# UNITED STATES PATENT AND TRADEMARK OFFICE

10/576,054

<b>Office Action Summary</b>	<b>Application No.</b> 10/576,054	<b>Applicant(s)</b> TANAKA, NAOYA	
	<b>Examiner</b> ANDARGIE M. AYCHILLHUM	<b>Art Unit</b> 2841

3. Claims 8-17 are rejected under 35 U.S.C 103 as being unpatentable over Fields et al. (US 4,821,007) in view of Annamalai et al. (US 6,798,168 B1).

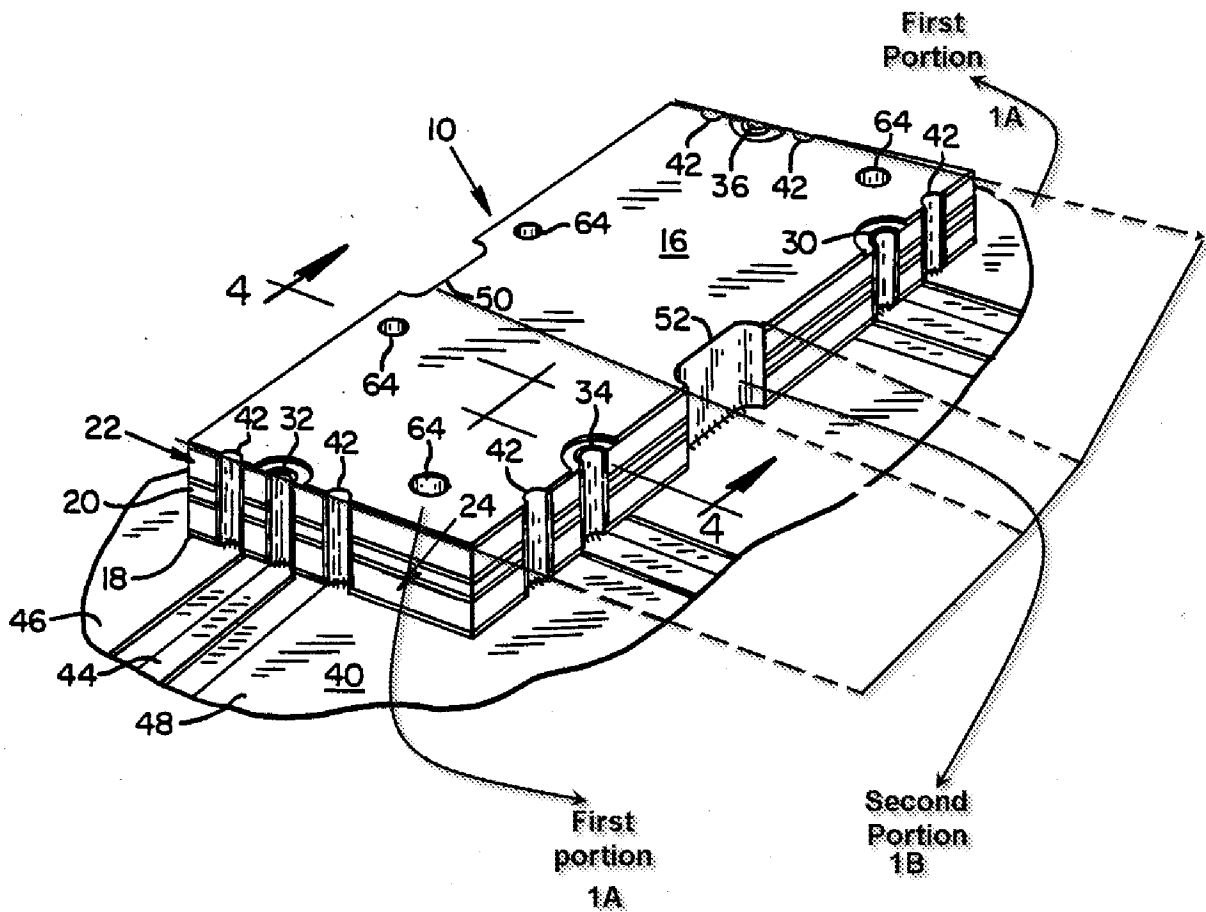
**Pertaining to claim 8**, Fields et al. discloses an elongate Wiring board (10, see figs. 1-3) having a first end and a second end (see figs. 1-3) ; wherein the wiring board (10) includes an intermediate stress concentrating portion (middle of 1A, see below Fields et al. fig. 1) located between the first (end of 1A) and second ends (end of 1B), a first mounting portion located between the first end and the intermediate stress concentrating portion (between 1A and 1B), and a second mounting portion located

between the second end and the intermediate stress concentrating portion (the other sides of 1A and 1B), the intermediate stress concentrating portion having a smaller cross section than the first and second mounting portions (see Fields figs. 1-3);

**Pertaining to claim 9**, Fields et al. as modified by Annamalai et al further discloses a second stress concentrating portion (between 1A and 1B, see Fields et al. fig. 1 above) located between the first end of the wiring board (10 of Fields) and the intermediate stress concentrating portion, and a third stress concentrating portion located between the second end of the wiring board (1B) and the intermediate stress concentrating portion; wherein the first electronic component (100 of Annamalai et al) is

**Pertaining to claim 10**, Fields et al. discloses the intermediate stress concentrating portion (between 1A and 1B, see Fields et al. fig. above) comprises a recess (below 52) (see figs. 1-3) for partially reducing a width of the wiring board (100).

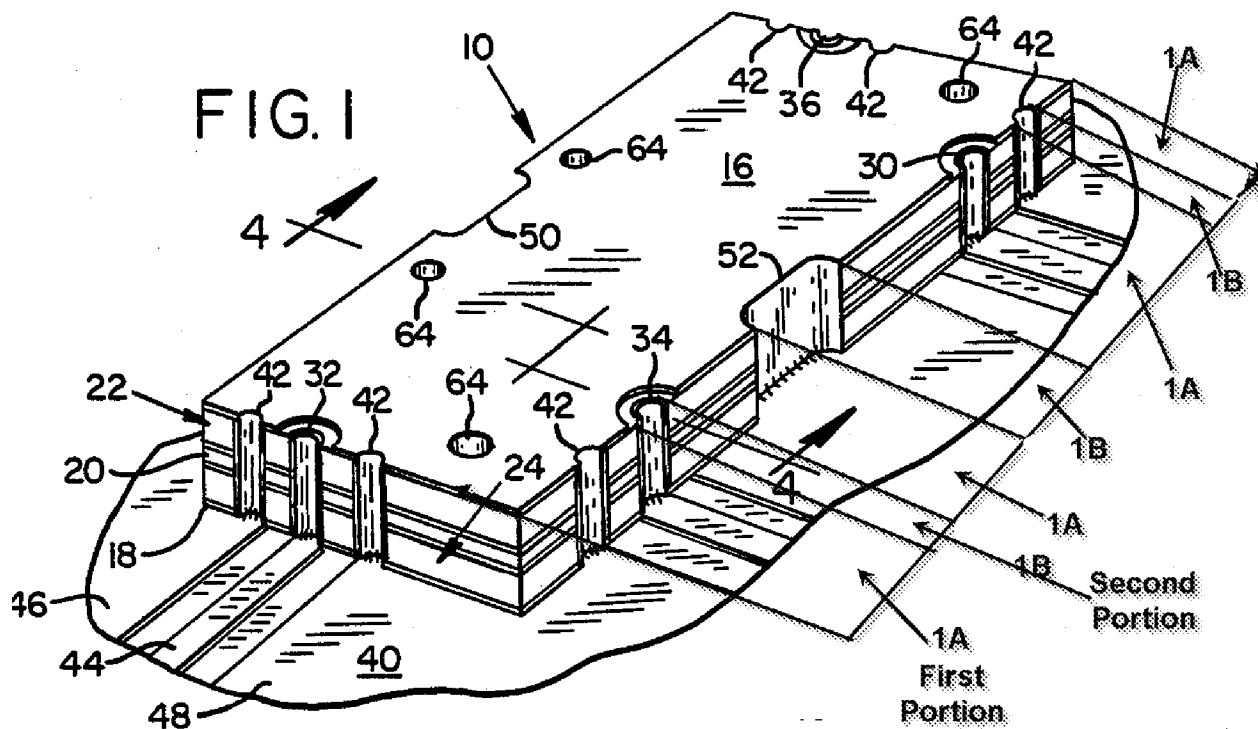
**Pertaining to claim 11**, Fields et al. discloses the intermediate stress concentrating portion (between 1A and 1B) comprises a hole (30, 32, 34 and 36, see figs. 1-3) penetrating the wiring board (100).

**Pertaining to claim 12**, Fields et al. discloses the wiring board (10) is provided with a groove (below 52) (see figs. 1-3) for partially reducing a thickness of the wiring board (10).

**Pertaining to claim 14**, Fields et al. discloses at least one of the intermediate stress concentration portion (between 1A and 1B, see Fields et al. fig. below), the second stress concentration portion (between 1B and 1A, see Fields et al. fig. below), and the third stress concentration portion (between 1B and 1A) comprises a recess (52) for partially reducing a width of the wiring board (10).

**Pertaining to claim 17**, Fields et al. further discloses at least one of the intermediate stress concentration portion (between 1A and 1B), the second stress concentration portion (between 1B and 1A), and the third stress concentration portion (between 1B and 1A) comprises a combination of a recess (52) and a groove (portion below 52), the recess partially reducing a width of the wiring board (10), the groove (the portion below 52, see fig. 1) partially reducing a thickness of the wiring board (10).
